GRACE IMMANUEL BIBLE CHURCH, SITE PLAN 10-39

Public Hearing at the request of Grace Immanuel Bible Church for Special Land Use Permit and Preliminary Site Plan approval. The subject property is located in Section 36, at 21900 Meadowbrook Road, north of Eight Mile Road and east of Meadowbrook Road, in the R-3, One-Family Residential District. The subject property is approximately 2.9 acres and the applicant is proposing an approximately 1,152 square foot addition to the north side of the existing church.

**SUBJECT: Grace Immanuel Bible Church, Preliminary Site Plan,
SP#10-39, Traffic Review**

Attachment

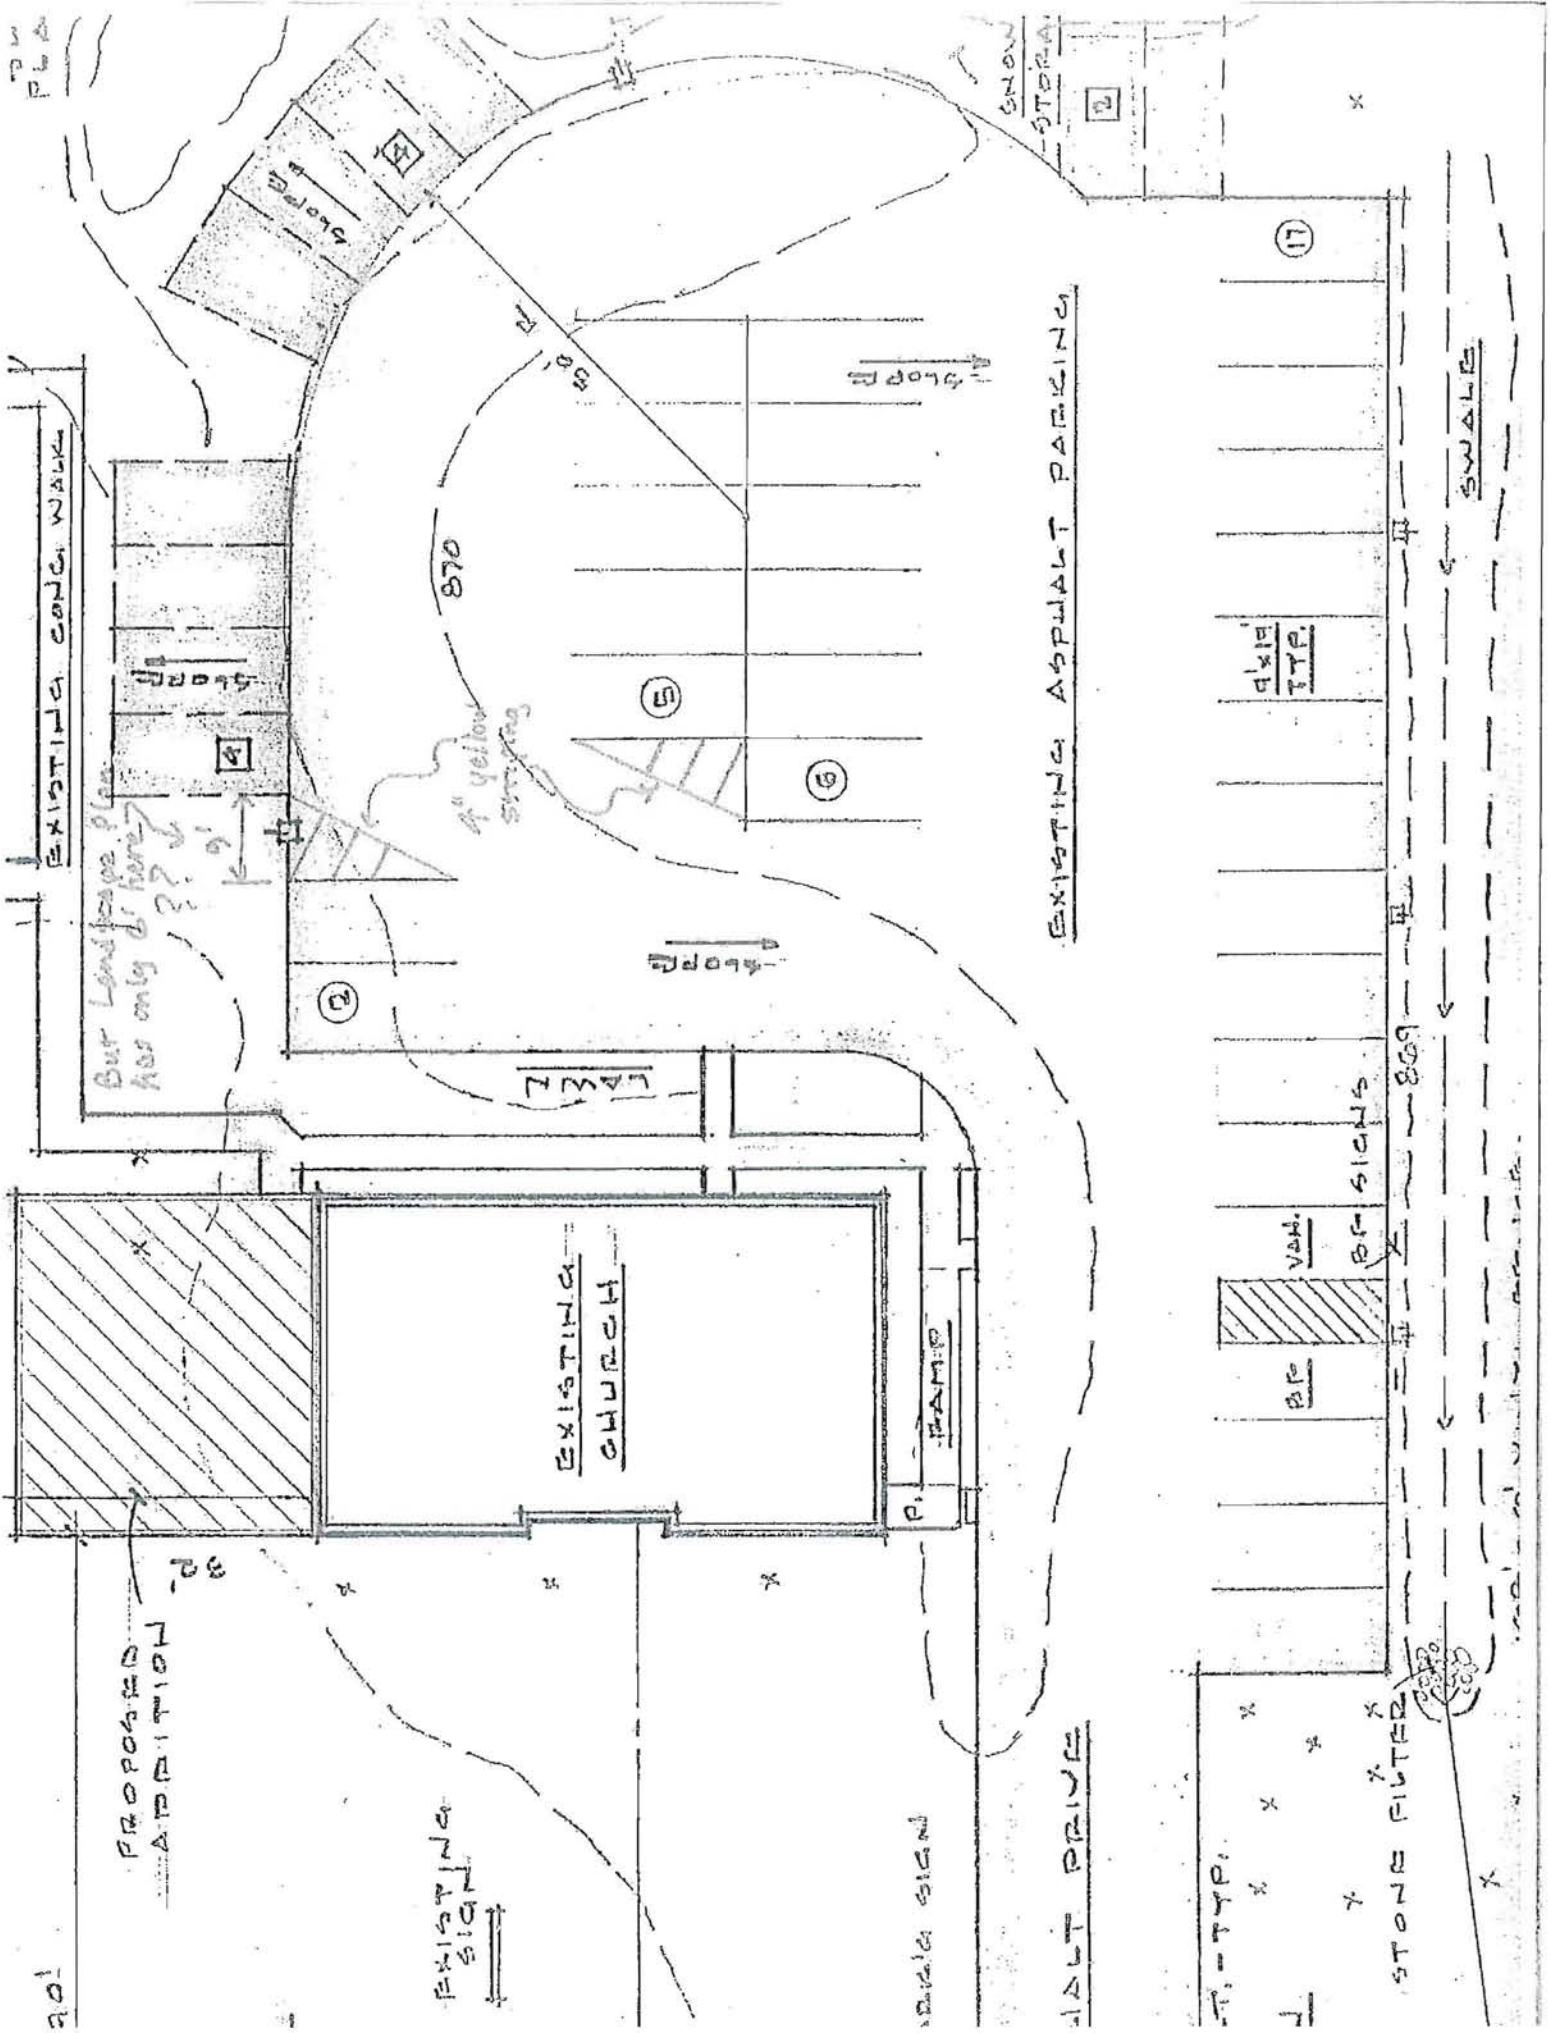
10. Given that the parking lot exists and will remain relatively unchanged (with the possible exception of ten spaces being added around the northern and eastern periphery), the Planning Commission may wish to waive the normal requirement for landscaped end islands. However, **to help ensure a clear maneuvering path for a large fire truck, parking should be discouraged – via yellow crosshatching – in the two locations shown in the attached plan mark-up.**

Our Landscape Plan
has only 6' here??

4" yellow
striking

BR signs
